PLANNING COMMISSION AGENDA

Tuesday, June 05, 2012
Breckenridge Council Chambers
150 Ski Hill Road

Planning Commission Staff Report

- Date:** May 29, 2012 (For meeting of June 6, 2012)
- Subject:** Welk Resorts Breckenridge Condo-Hotel, Worksession
- Proposal:** The applicants are proposing a 72-unit Condo-hotel. In addition, they are proposing to modify the Third Amended Master Plan of the Delaware Flats Planning Area 3A, by modifying the recently platted Tract C-1, C-2, and a future platted portion of Tract A, Shores Master Plan Modification, and Subdivision.

Welk Resorts - Breckenridge
Site Plan Concept

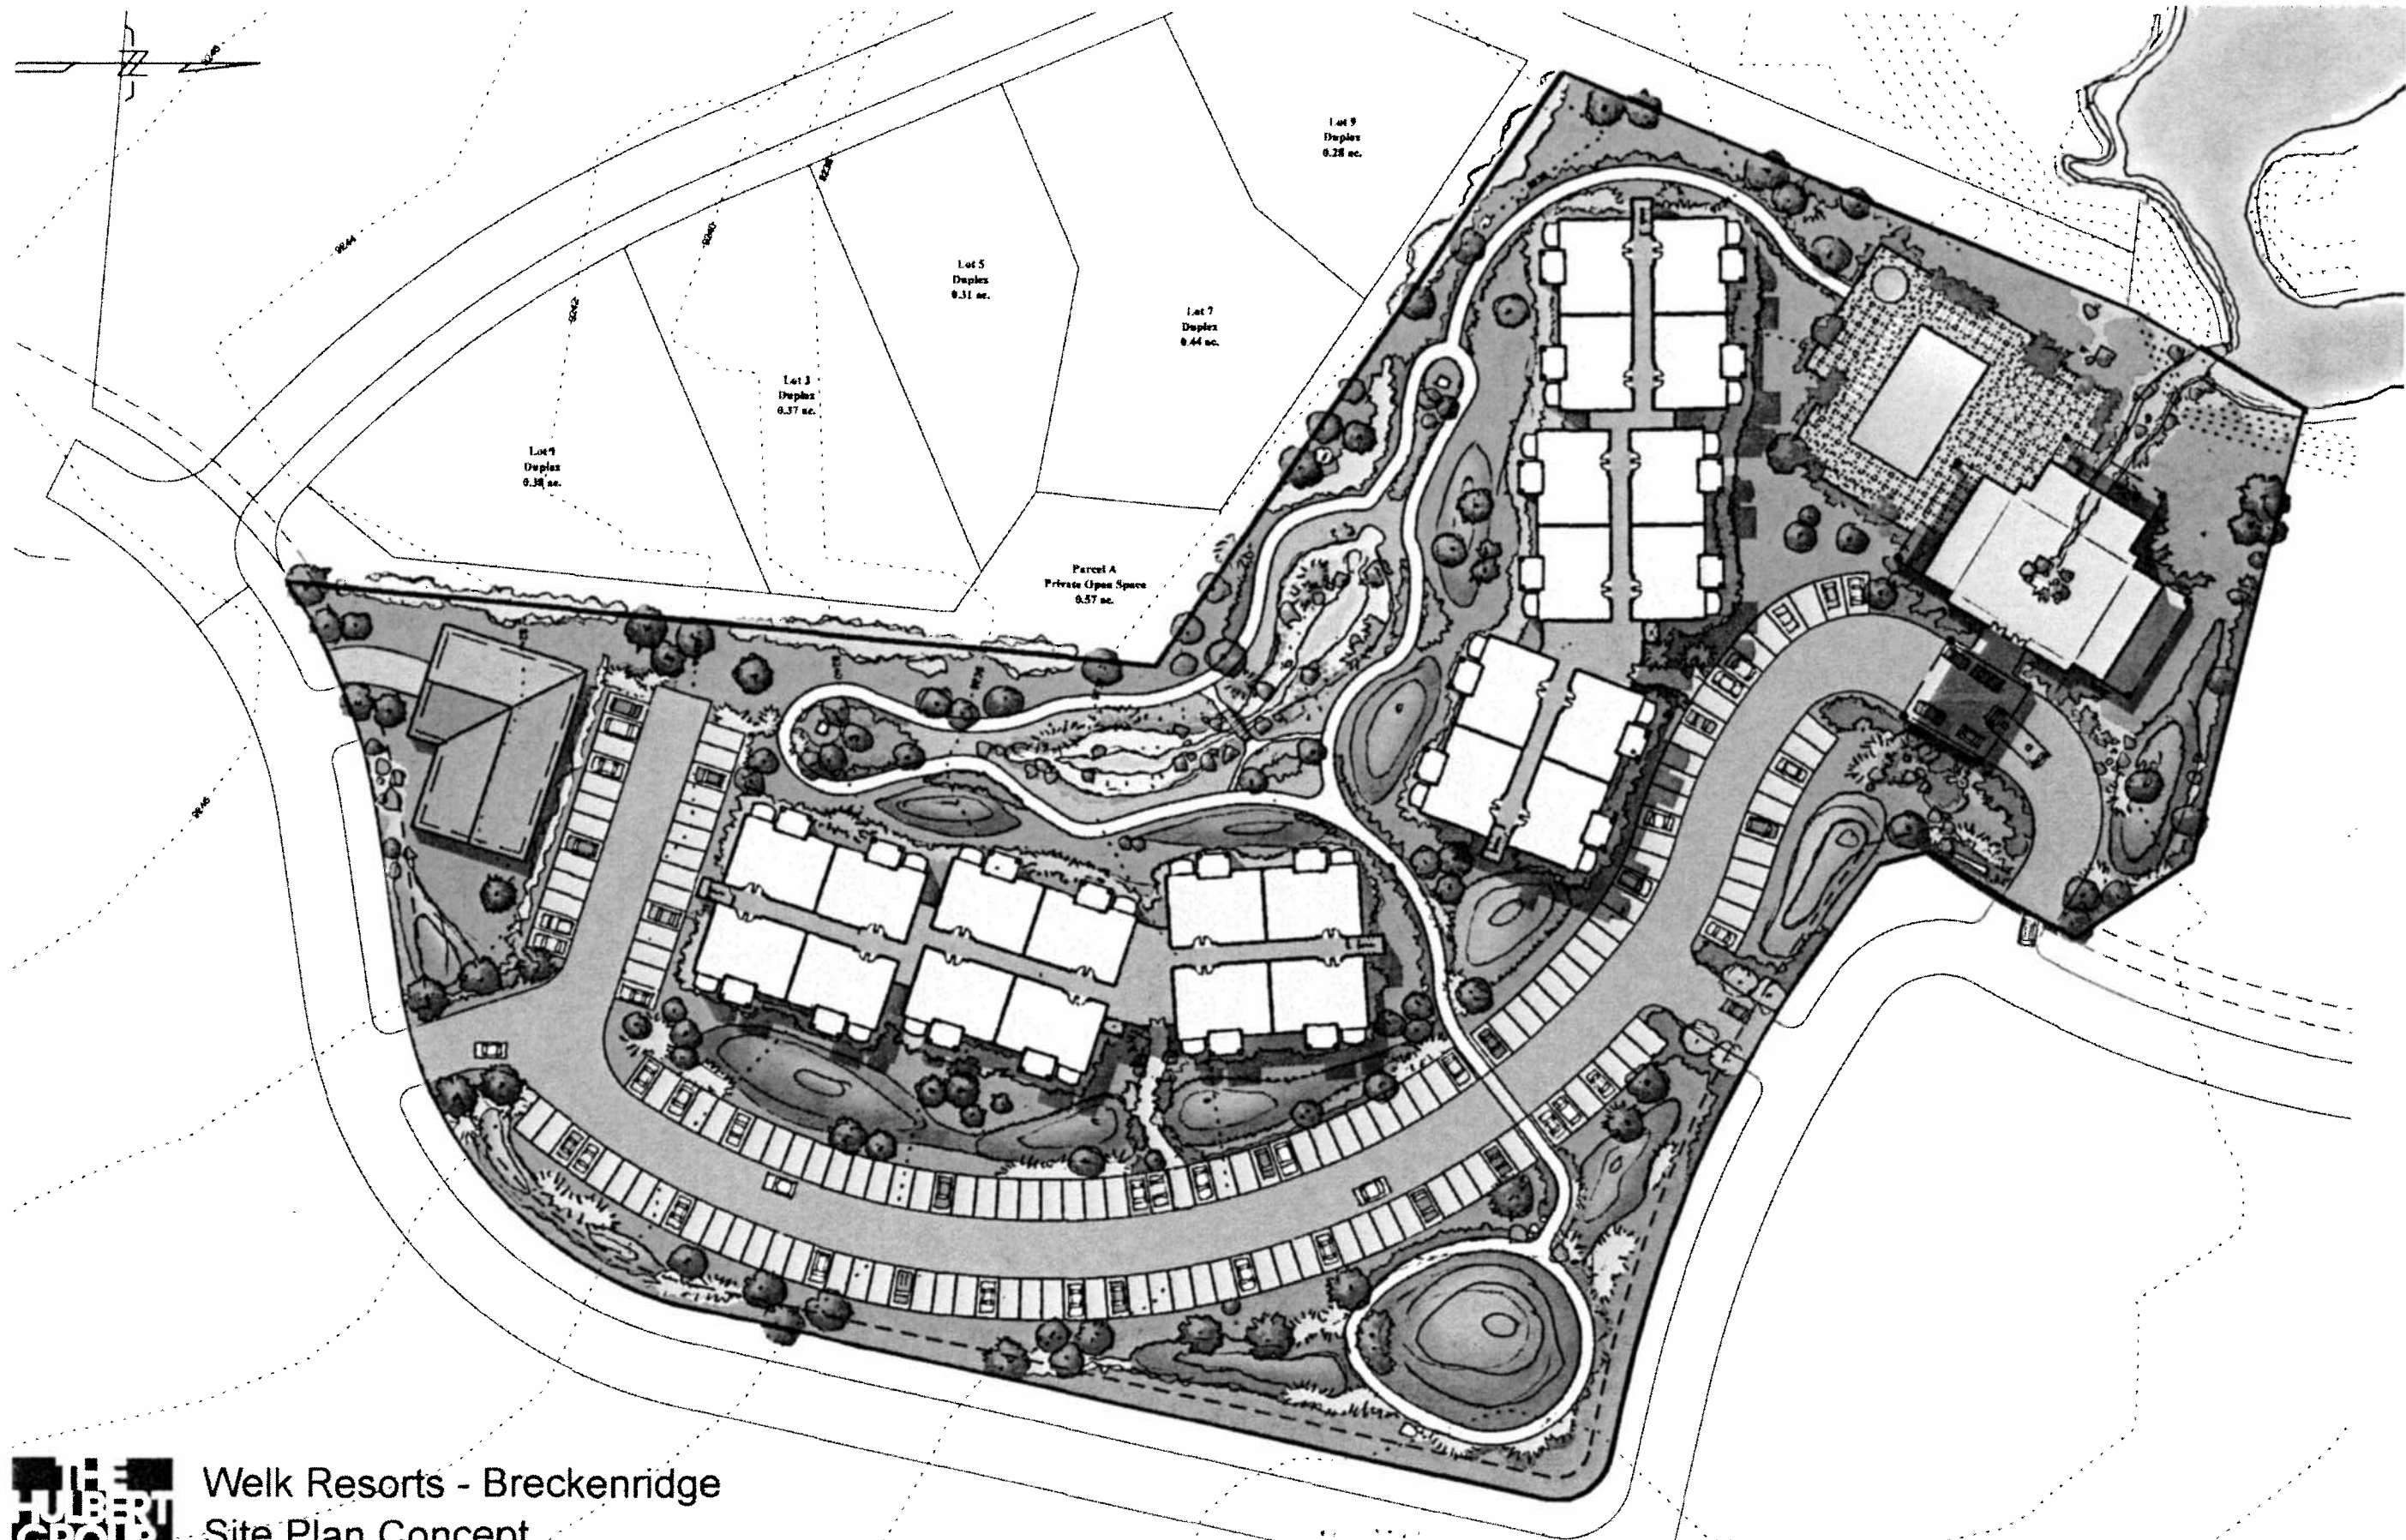
Due to the high water table on site, all project parking will be surface parking. The parking currently shown represents between 120-150 parking spaces. At 1.5 parking spaces per unit, 108 parking spaces would be necessary. As shown on the illustrative site plan, all parking will be screened with landscape berms and vegetation.

At this time staff has identified concerns over the layout of the parking area. We believe the expanse of parking should be broken up with pockets of landscaping and that a berm be added along the edge abutting the Right of Way. Does the Commission concur?

**Character
Elevation
Concept**

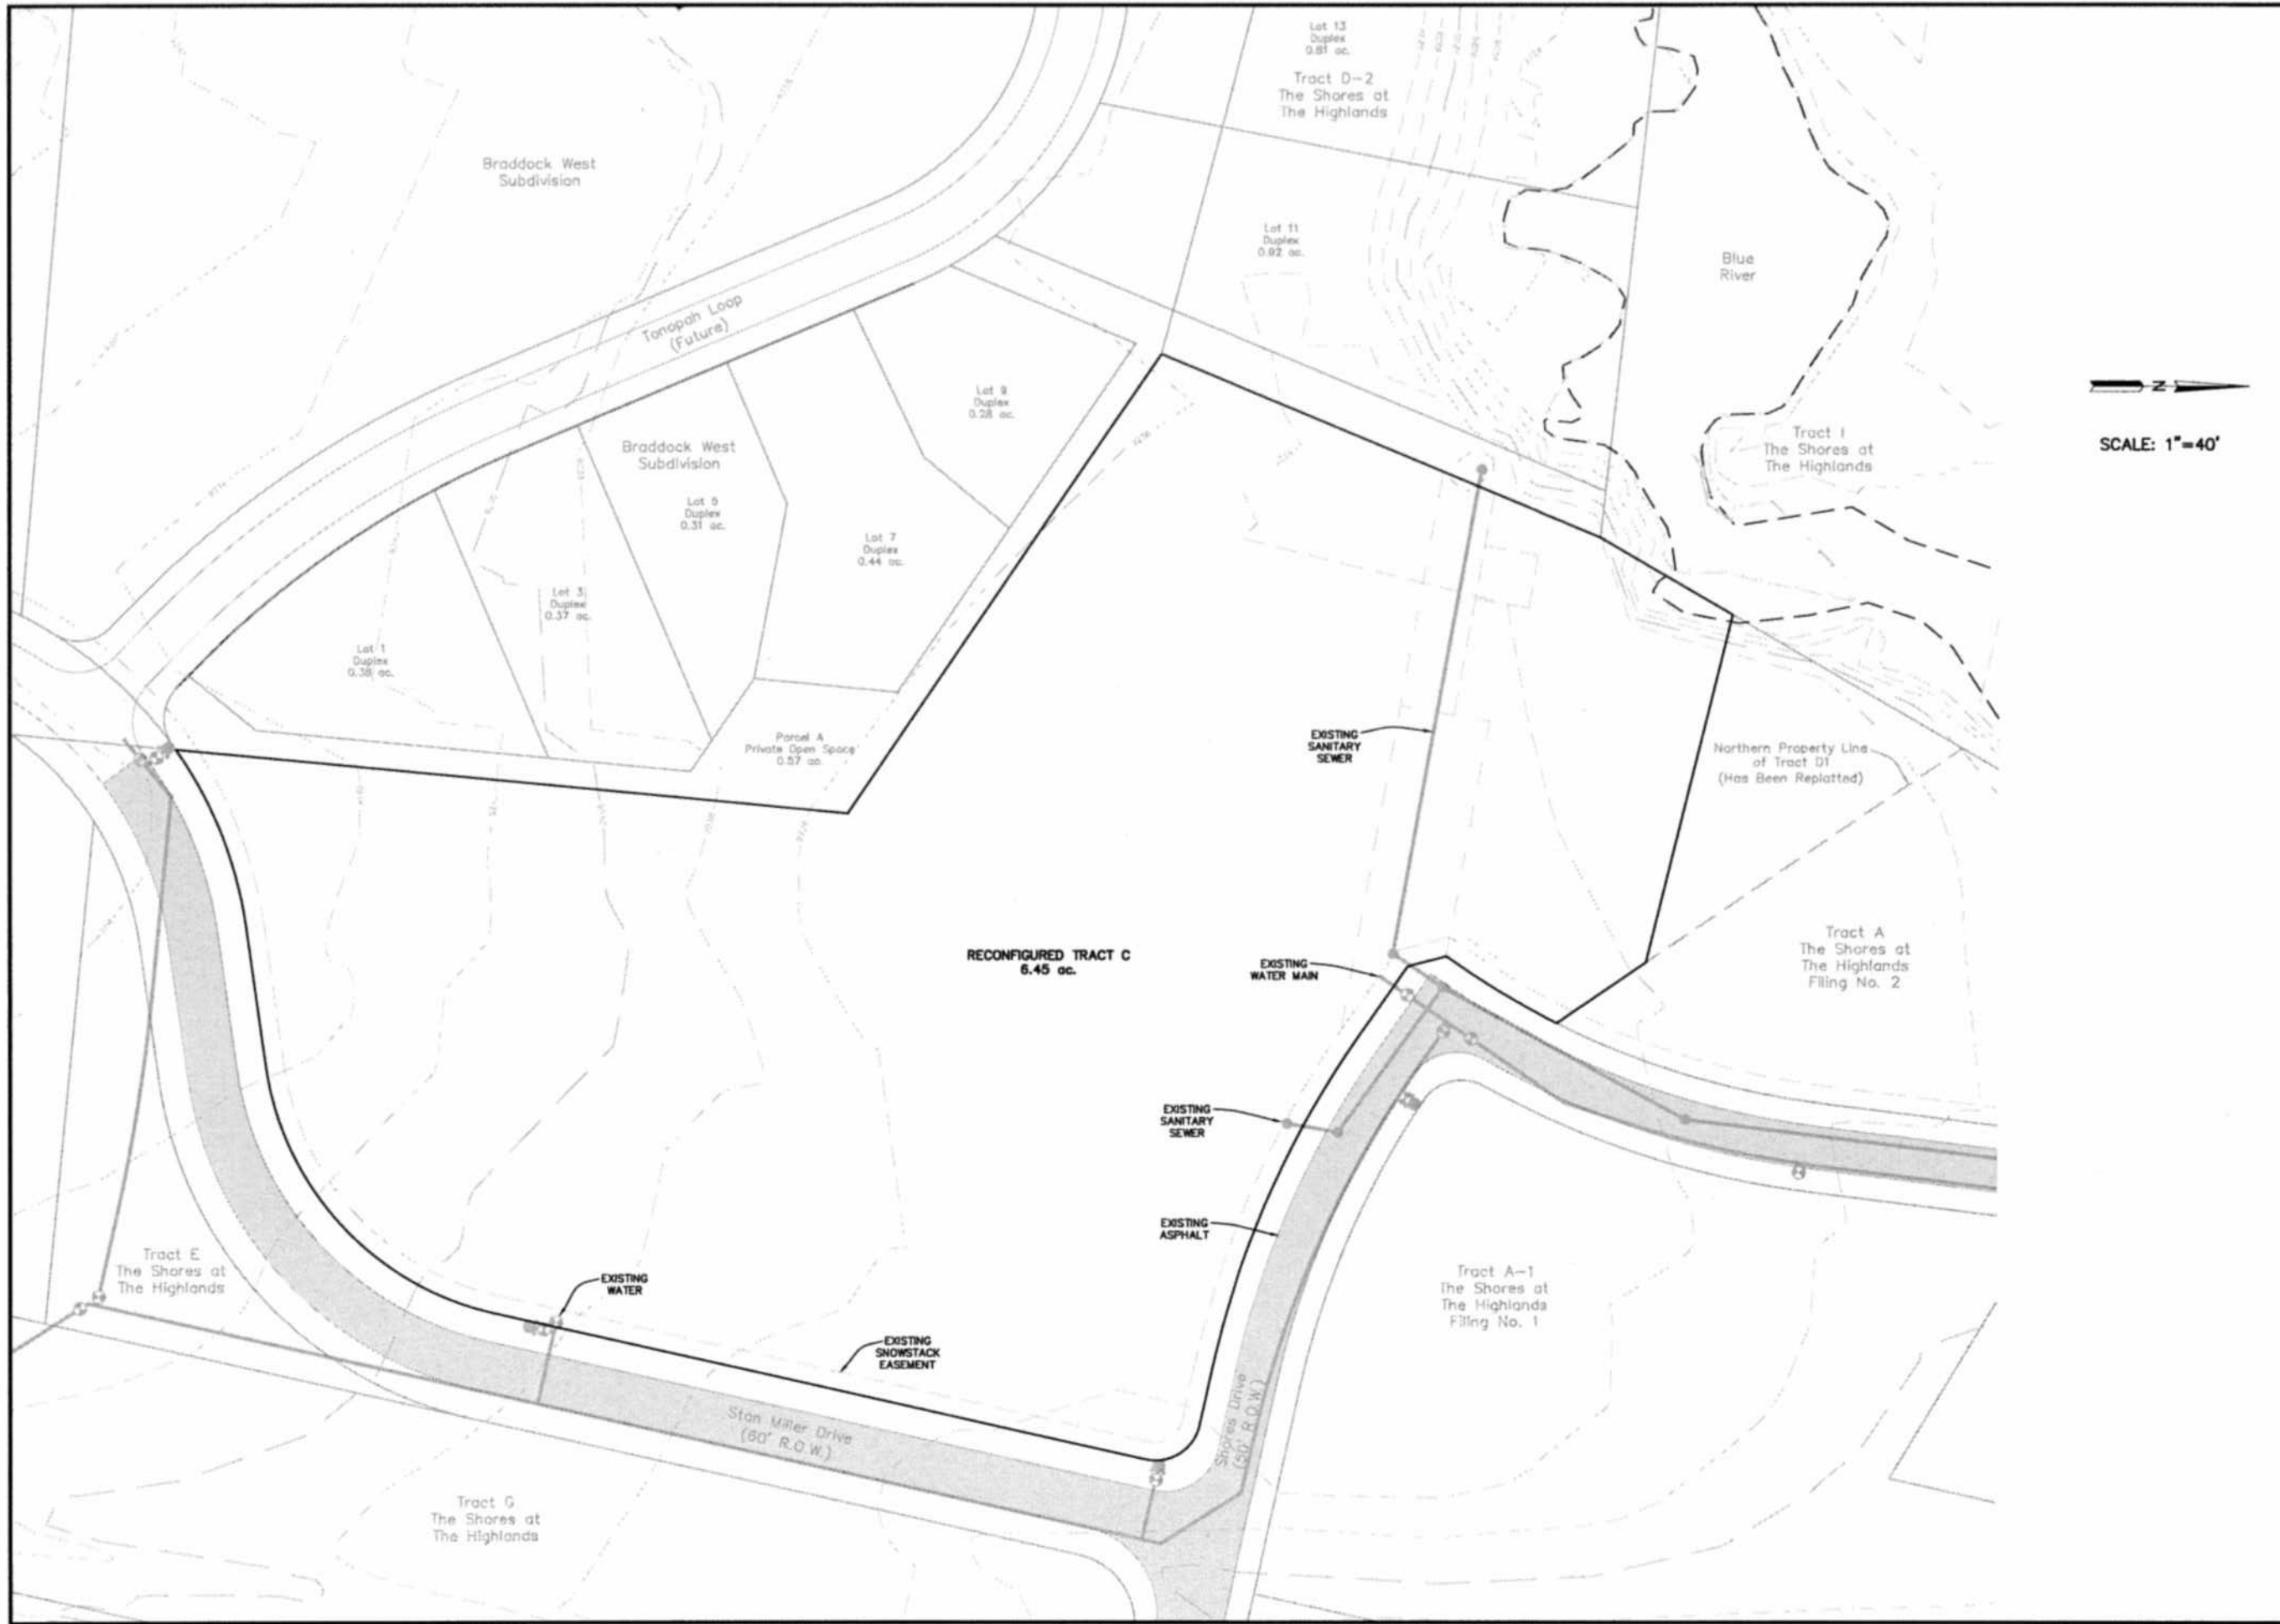
At this preliminary review, the sample elevations show contemporary mountain architecture with broken up masses. The roof forms are stepping down at the edges. The massing of the two buildings has been broken up nicely with an undulating footprint. There is some repetition of “module-bays” on each elevation with a unique connecting element joining each of the masses.

Though not specifically noted on the drawings, we anticipate that the materials will abide with the master plan. We welcome any comments on the proposed architecture.
